<b>Title - Sujet</b> CCGC Mechanical and Sprinklers	
<b>Solicitation No. - N° de l'invitation</b> EB144-190543/A	<b>Amendment No. - N° modif.</b> 008
<b>Client Reference No. - N° de référence du client</b> EB144-19-0543	<b>Date</b> 2018-08-14
<b>GETS Reference No. - N° de référence de SEAG</b> PW-\$PWA-121-5750	
<b>File No. - N° de dossier</b> PWA-8-80020 (121)	<b>CCC No./N° CCC - FMS No./N° VME</b>
<b>Solicitation Closes - L'invitation prend fin</b> <b>at - à 02:00 PM</b> <b>on - le 2018-08-21</b>	<b>Time Zone</b> <b>Fuseau horaire</b> Atlantic Daylight Saving Time ADT
<b>F.O.B. - F.A.B.</b> <b>Plant-Usine:</b> <input type="checkbox"/> <b>Destination:</b> <input checked="" type="checkbox"/> <b>Other-Autre:</b> <input type="checkbox"/>	
<b>Address Enquiries to: - Adresser toutes questions à:</b> Russell (PWA), Alex	<b>Buyer Id - Id de l'acheteur</b> pwa121
<b>Telephone No. - N° de téléphone</b> (902) 401-8180 ( )	<b>FAX No. - N° de FAX</b> (902) 496-5016

**ADDENDUM NO. 2**

**Item 3.1 DRAWING 01-MC-101 CONTROLS – CABOT - SCHEMATICS**

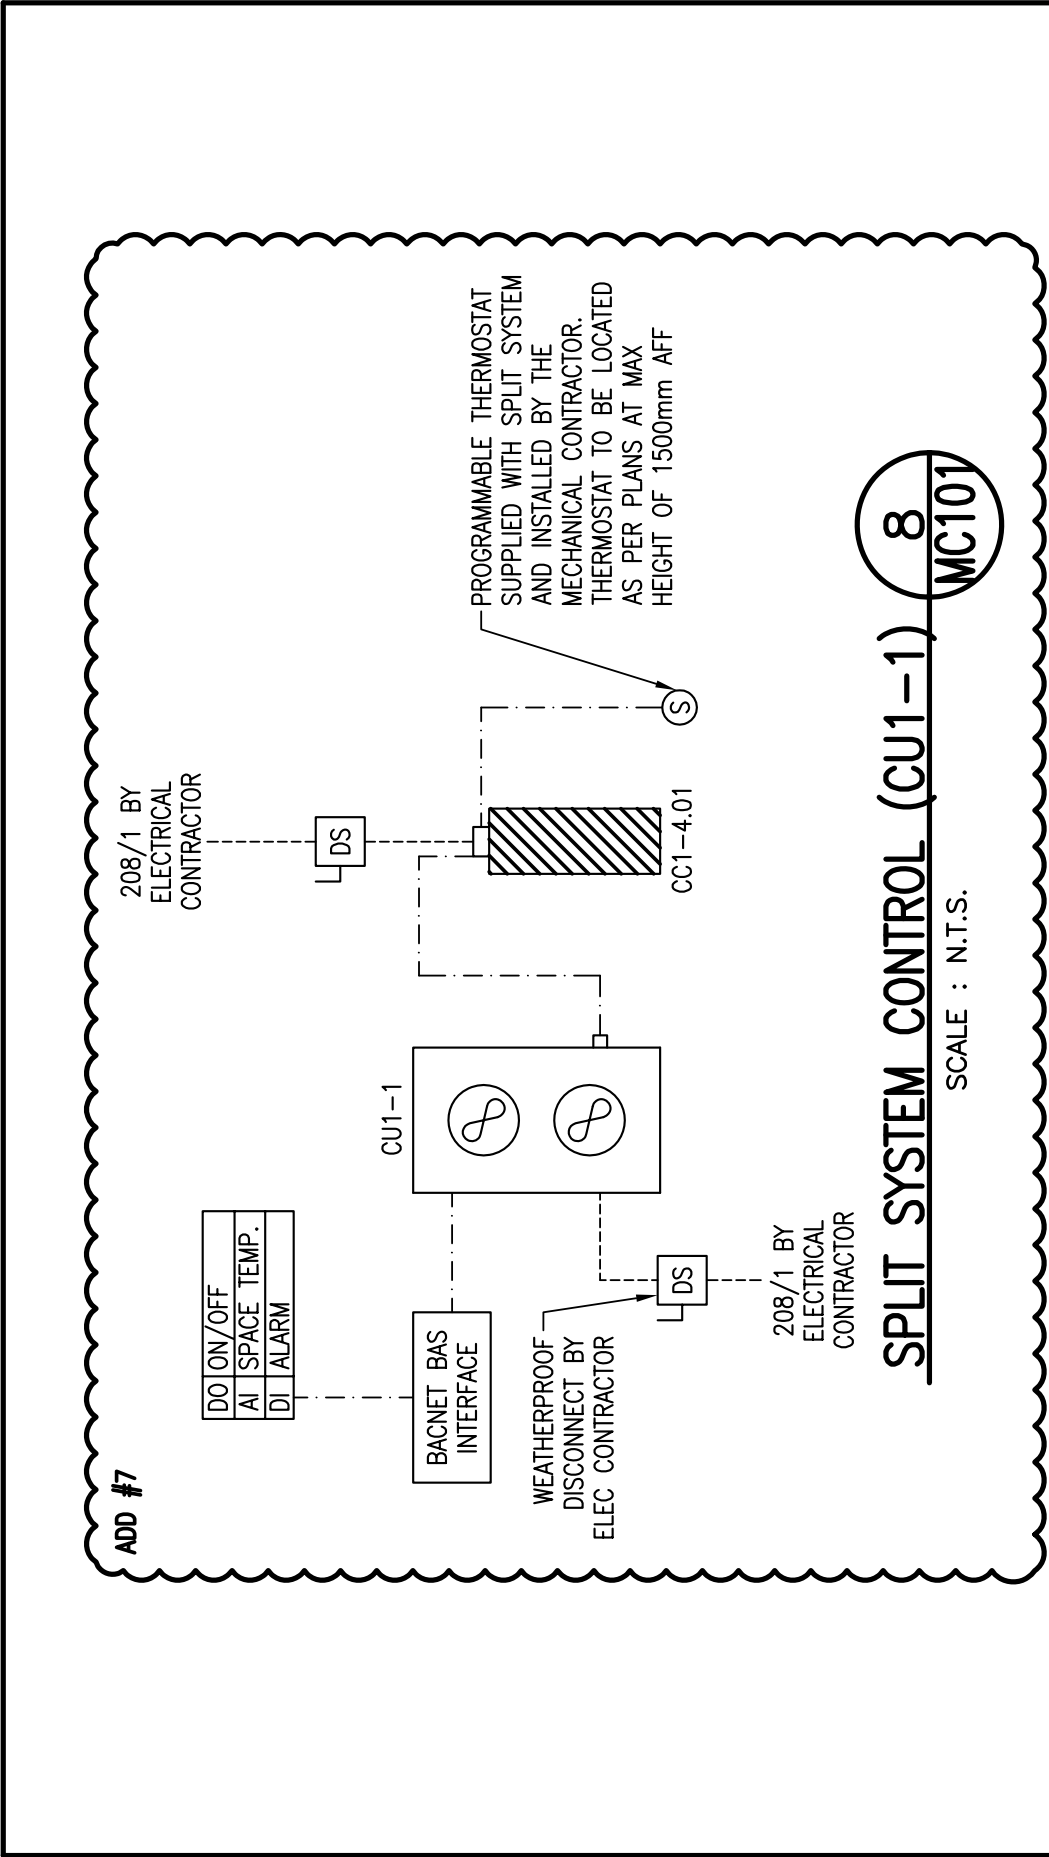
**Item 3.2 DRAWING 01-MC-103 CONTROLS CABOT - SCHEMATICS**

.1 Revise the drawing as per the attached Sketch 01-MC-SK001 (This Addendum).

Reference Drawing: 01-MDP-107

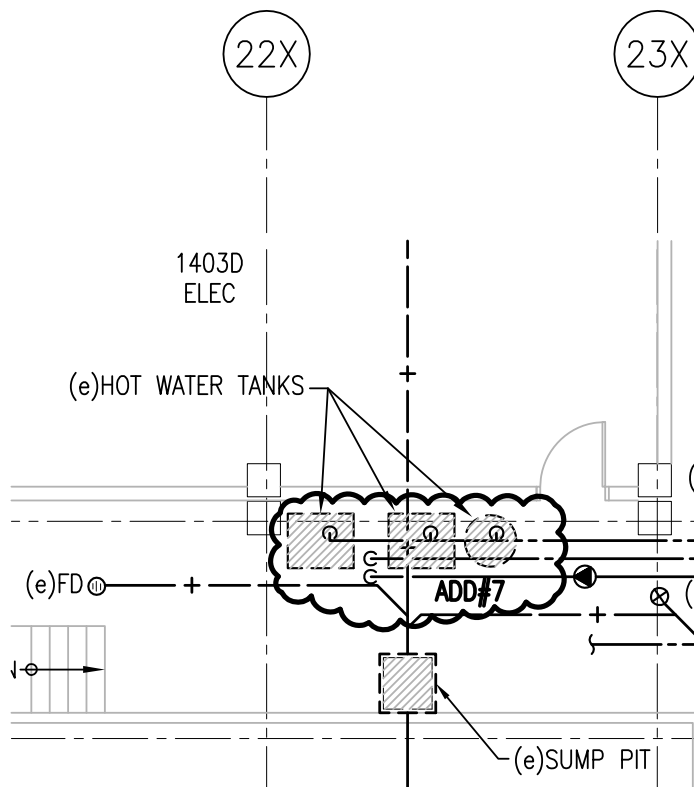
**Item 3.12      DRAWING 01-MDP-107 PLUMBING - CABOT EAST - LEVEL 100 DEMOLITION**

- .1      Revise the drawing as per the attached sketch 01-MDP-SK001.

Reference Drawing: 01 – MH – 602

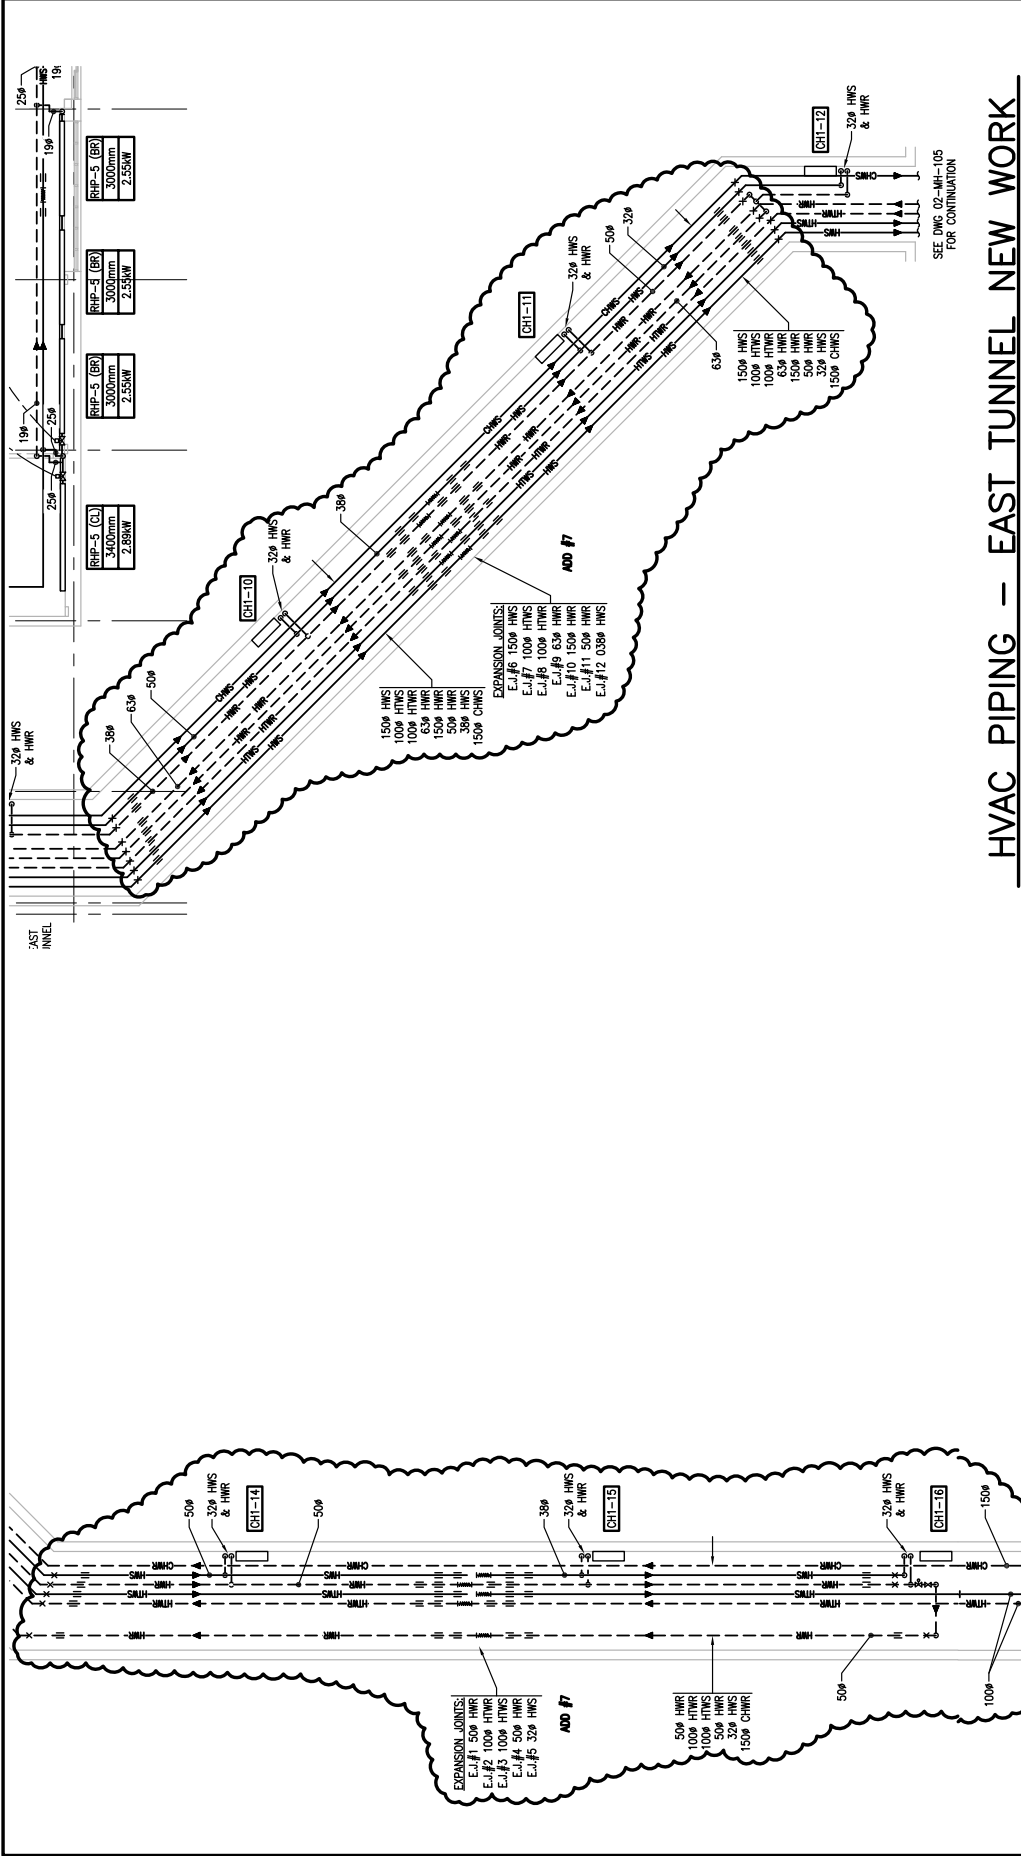
**Item 3.11      DRAWING 01-MH-602 - HVAC PIPING – CABOT SCHEDULES**

- .1      Revise Pump Schedule per sketch 01-MH-SK008 (This Addendum).
- .2      Add Expansion Tank Schedule per sketch 01-MH-SK009 (This Addendum).
- .3      Add Air Separator Schedule per sketch 01-MH-SK010 (This Addendum).
- .4      Add Heating Coil Schedule per sketch 01-MH-SK013 (This Addendum).
- .5      Revise the drawing as per the attached Sketch 01-MH-SK014 (This Addendum).

Reference Drawing: 01-MP-501

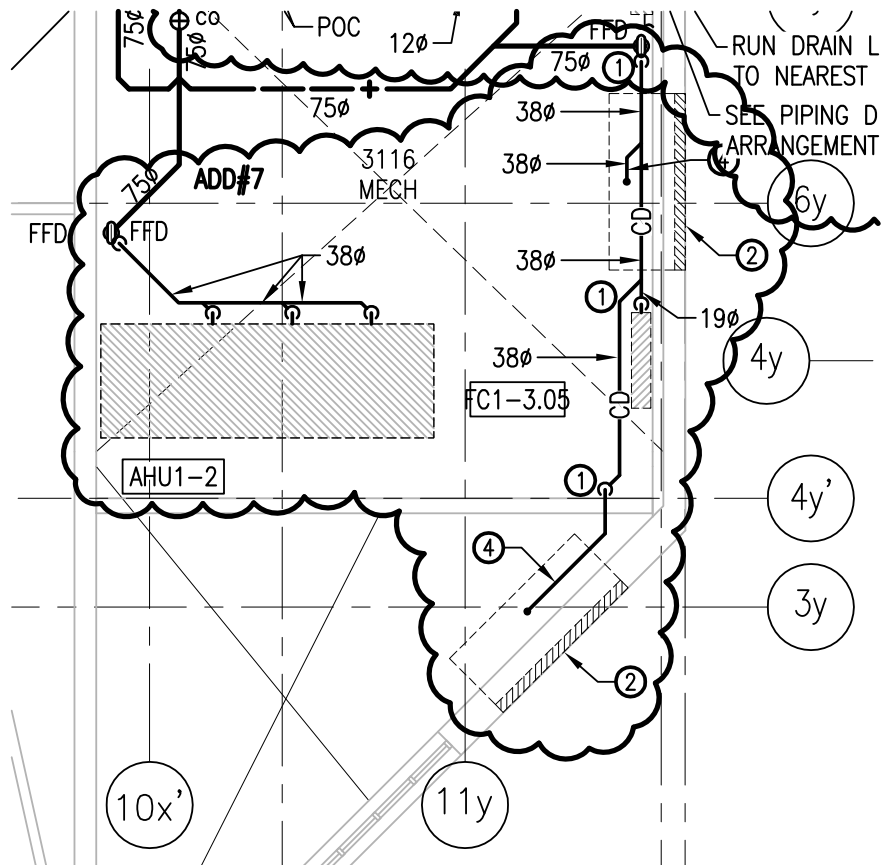
**Item 3.18      DRAWING 01-MP-501 - CABOT - PLUMBING DETAILS**

- .1      Revise pipe sizing on Detail 8 of this drawing per Sketch 01-MP-SK006 Pipe Sizing for Humidifier Piping Detail dated 2018-08-10 (This Addendum).

Reference Drawing: 01-MV-605

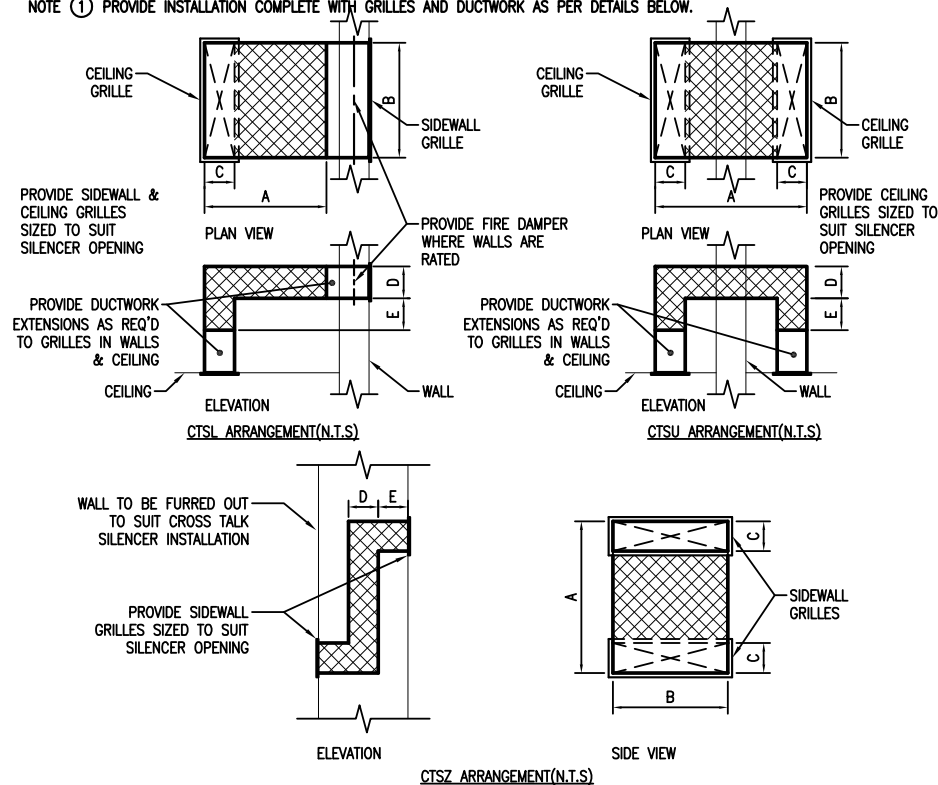
**Item 3.23      DRAWING 01-MV-605 - VENTILATION - CABOT SCHEDULES**

- .1      Provide installation of cross talk silencers complete with ductwork and grilles as detailed per sketch 01-MV-SK008 (This Addendum).

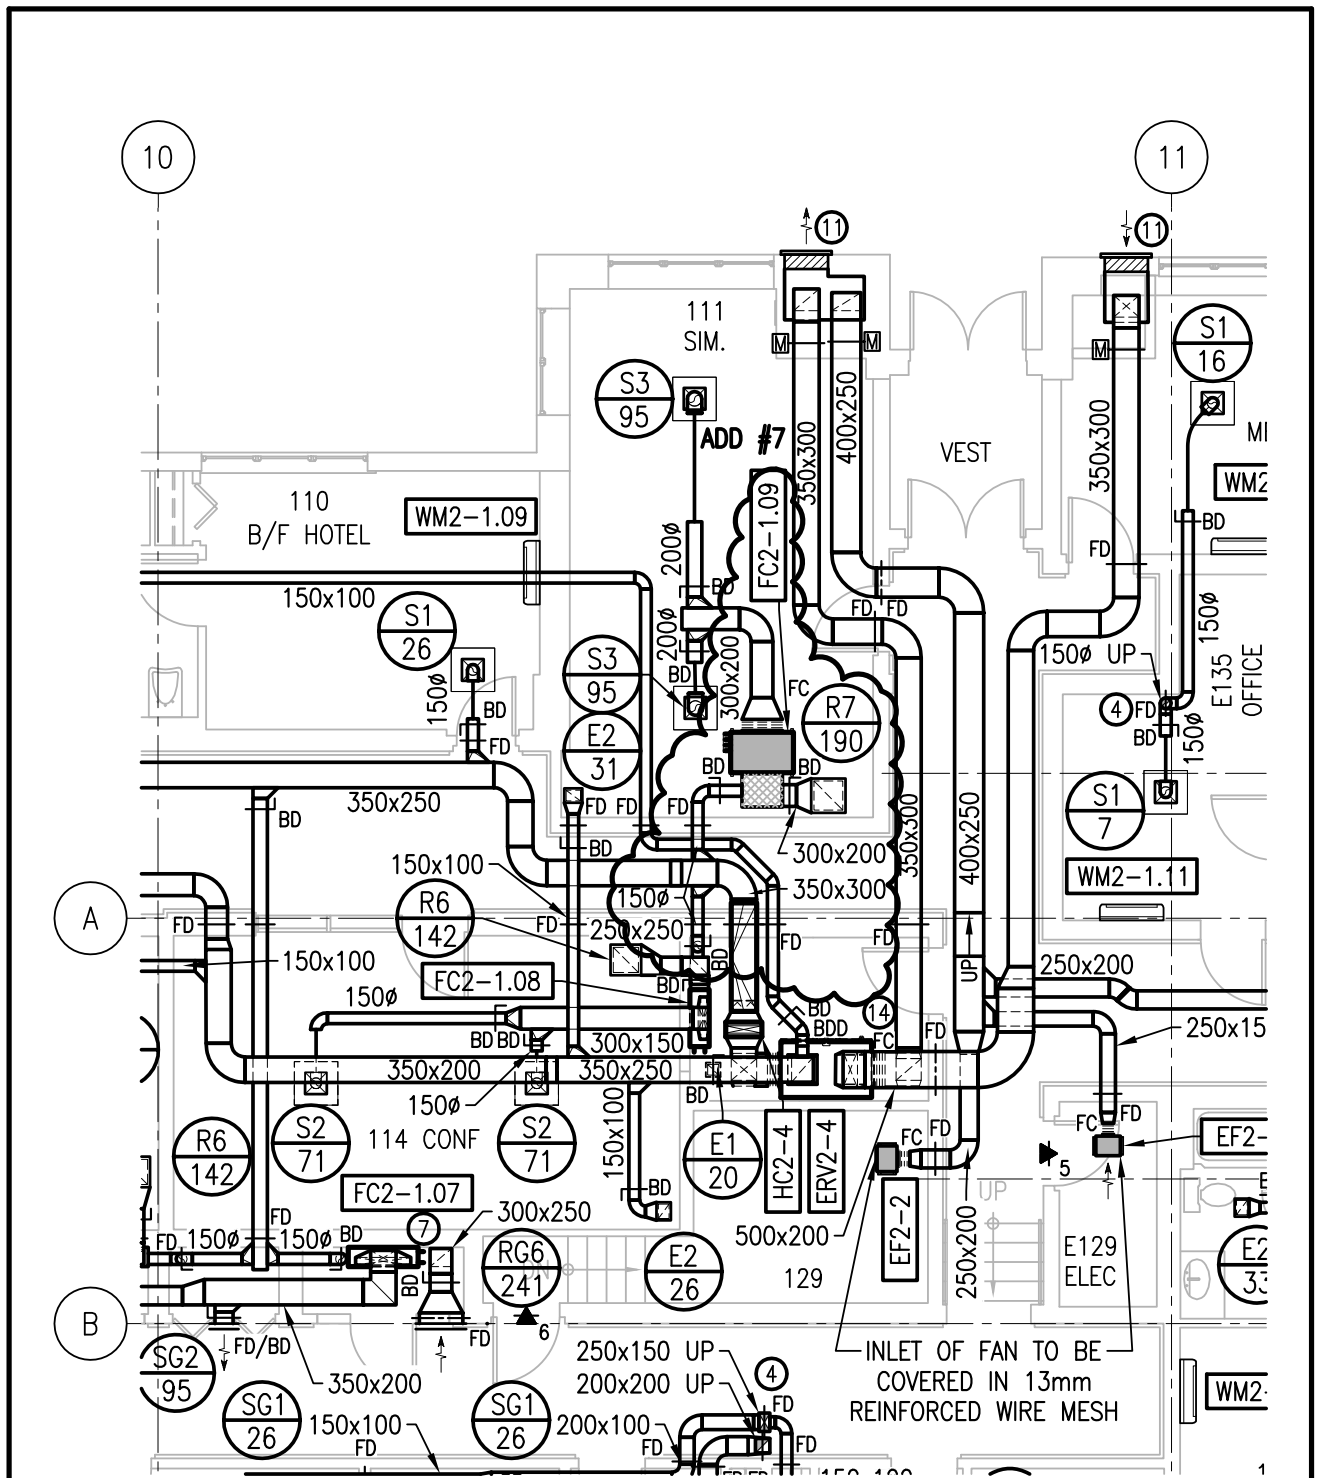
**Item 3.26      DRAWING 02-MP-101 PLUMBING ARCTIC LEVEL 100 & 200 NEW WORK**

- .1      Add humidifier HU2-4 to Mech Room E113 per Sketch 02-MP-SK001 Addition of Humidifier HU2-4 in Mech Rm 113 dated 2018-08-10 (This Addendum).
- .2      Revise condensate drain piping to relocated fan coil FC2-1.09 per Sketch 02-MP-SK002 Relocated FC2-1.09 Condensate Line Addition dated 2018-08-10 (This Addendum).

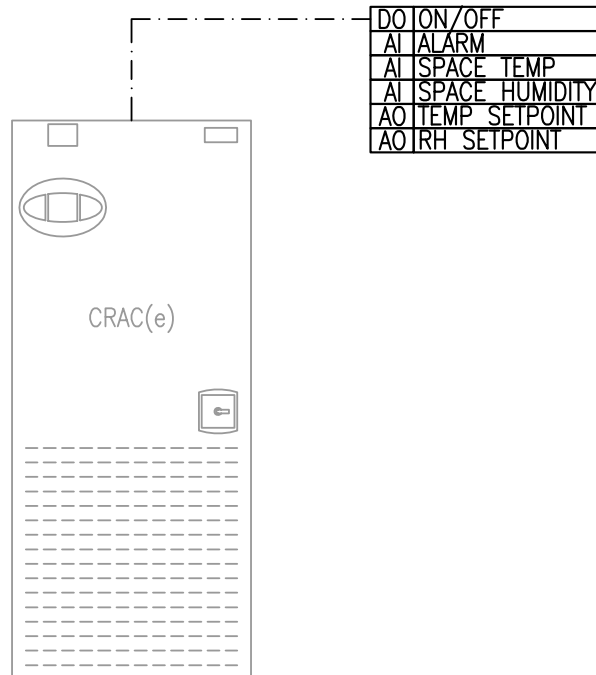
**Item 3.27      DRAWING 02-MV-101 VENTILATION ARCTIC LEVEL 100 & 200 NEW WORK**

- .1      Revise location of fan coil FC2-1.09 and associated ductwork per Sketch 02-MV-SK001 Fan Coil FC2-1.09 Revisions dated 2018-08-10 (This Addendum).

Reference Drawing: 05-MDP-101

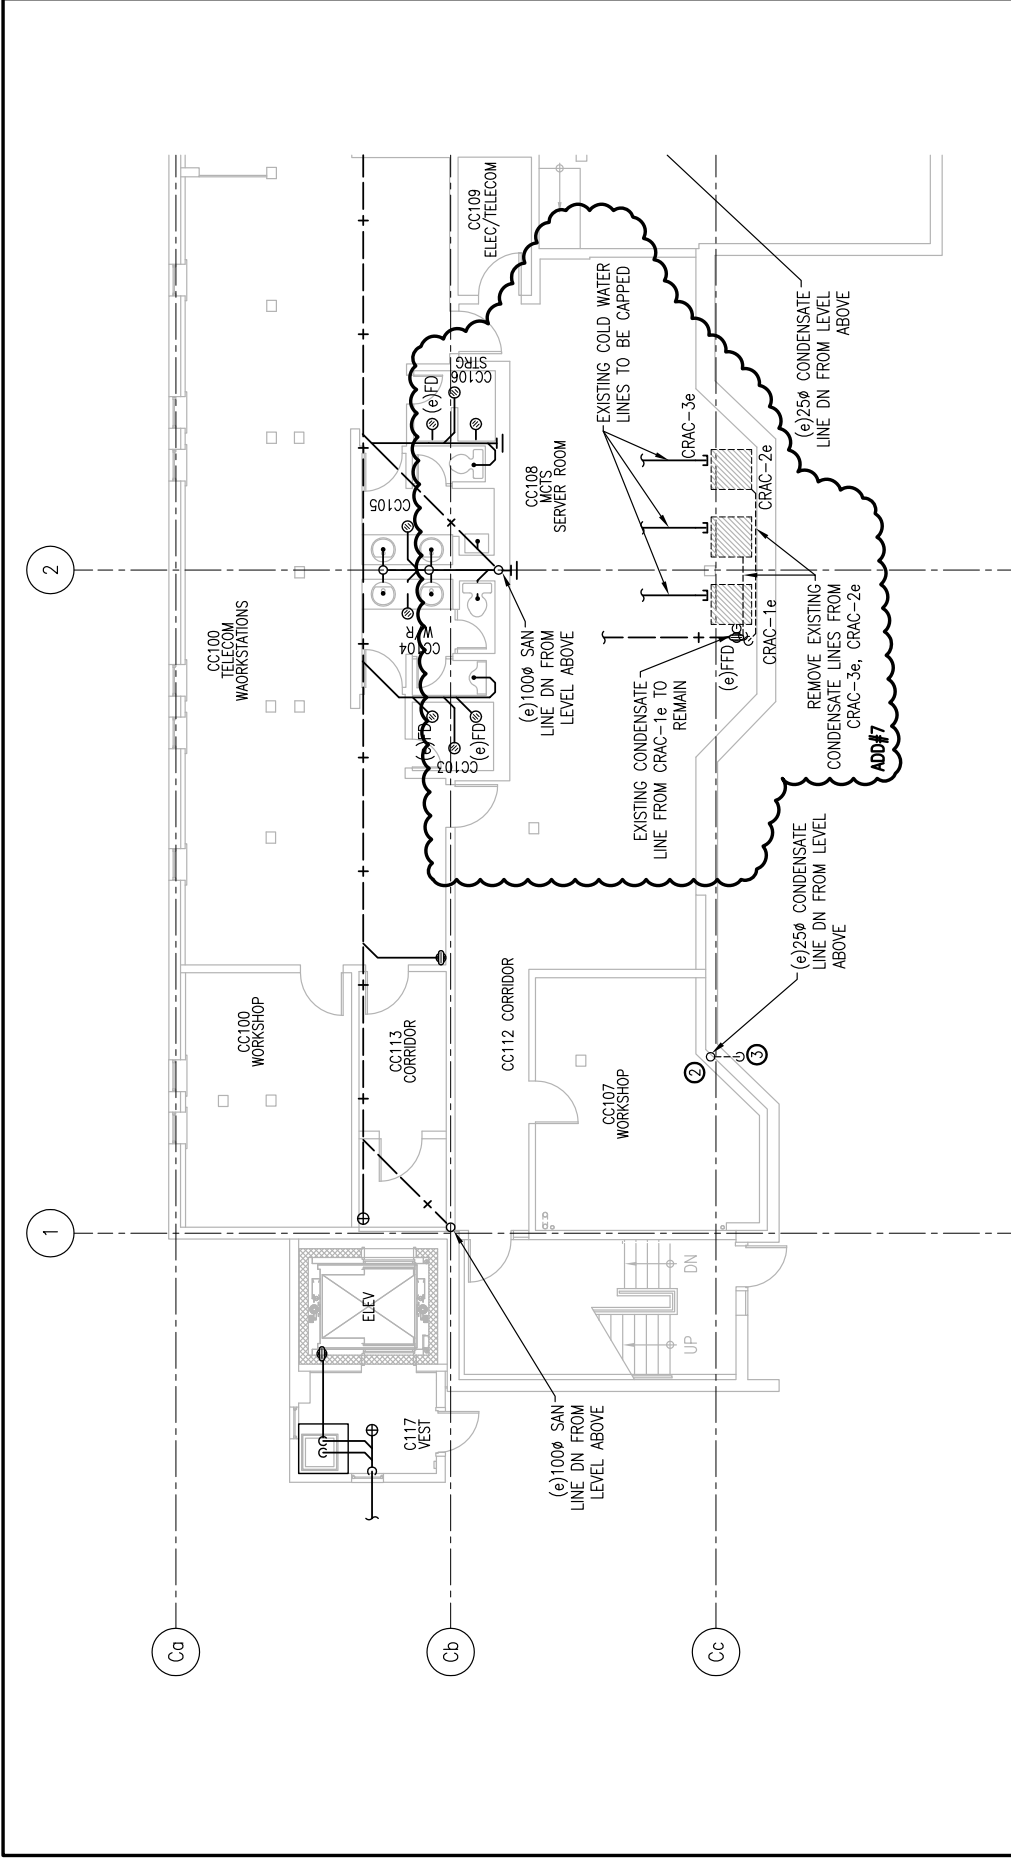
**Item 3.44      DRAWING 05-MDP-101 PLUMBING – TELC/MCTS – LEVEL 100 – 200 DEMOLITION**

- .1      Revise the drawing as per the attached Sketch 05-MDP-SK001 (This Addendum).
